City of Olathe

**STAFF REPORT****Planning Commission Meeting: December 10, 2018**

<b>Application:</b>	<b><u>RZ18-0016:</u> Rezoning from R-1 to C-3 and R-4 District and preliminary development plan for Stag's Ridge</b>
<b>Location:</b>	Northwest of K-7 and Spruce Street intersection
<b>Owner:</b>	Steve Jensen, Arthur E. Jensen, Inc.
<b>Applicant:</b>	Kevin Tubbesing, Stag's Ridge, L.L.C.
<b>Engineer:</b>	Dan Jensen, Schlagel & Associates
<b>Staff Contact:</b>	Dan Fernandez, Planner II

**STAG'S RIDGE  
PRELIMINARY DEVELOPMENT PLAN  
K-7 HIGHWAY AND SPRUCE STREET  
OLATHE, KANSAS**

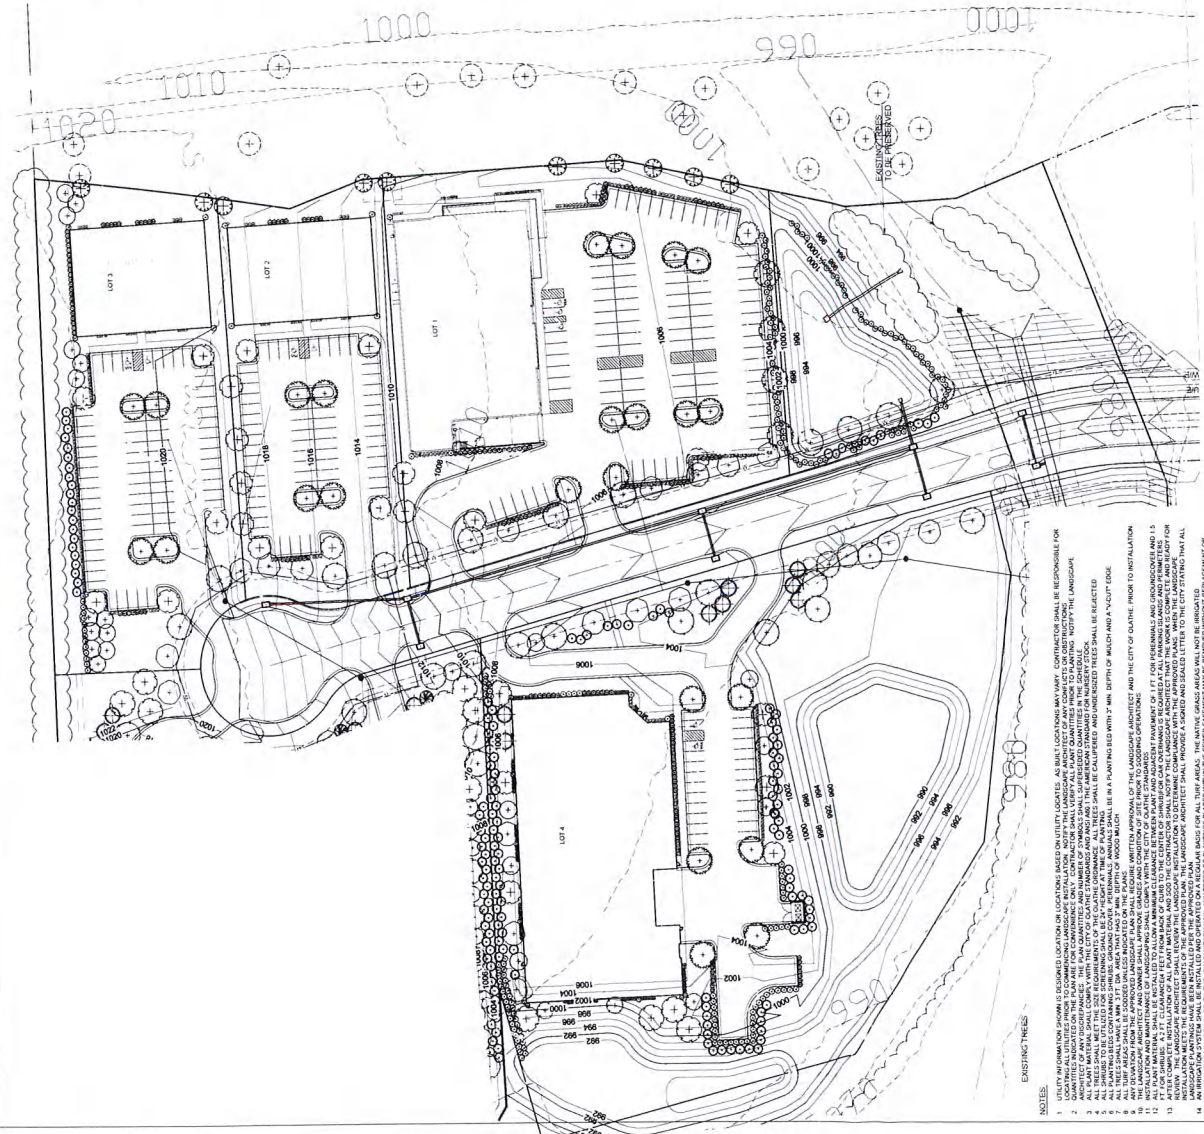
As the development on the north side of the subject site is conceptual, staff will continue to work with any developer to increase the number of trees saved along the north property line with the revised preliminary site development plans. And although fencing is not required in the buffer when saving existing vegetation, staff will also look at adding fencing on the north side of the development as additional screening for Ernie Miller Park and Nature Center.

The south property line of the proposed senior housing lot requires a 75-foot buffer per the *UDO* as this site abuts what will be a commercially zoned property. Currently a 40-foot buffer is shown. This requirement will be revisited with the revised preliminary site development plan and the proper waiver requested if necessary.

**SITE SECTION**

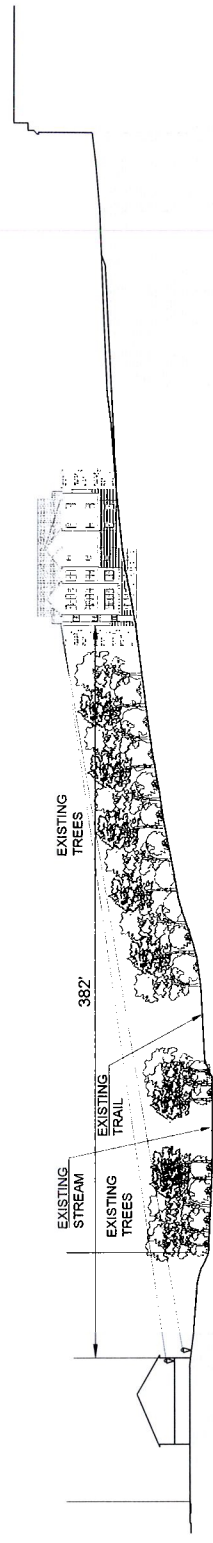
The north property line for the proposed development is shared with Ernie Miller Park and Nature Center. The senior housing facility which is shown as 4 stories, is setback approximately 109 feet from the north property line. Garages for the multi-family building are setback 30 feet from this property line. The proposed commercial building closest to Ernie Miller will be less than 40 feet as required by the *UDO*. Also, the subject site falls off going south so that will further lessen the impact of any buildings on the nature center as the buildings for this development will sit at a lower grade.
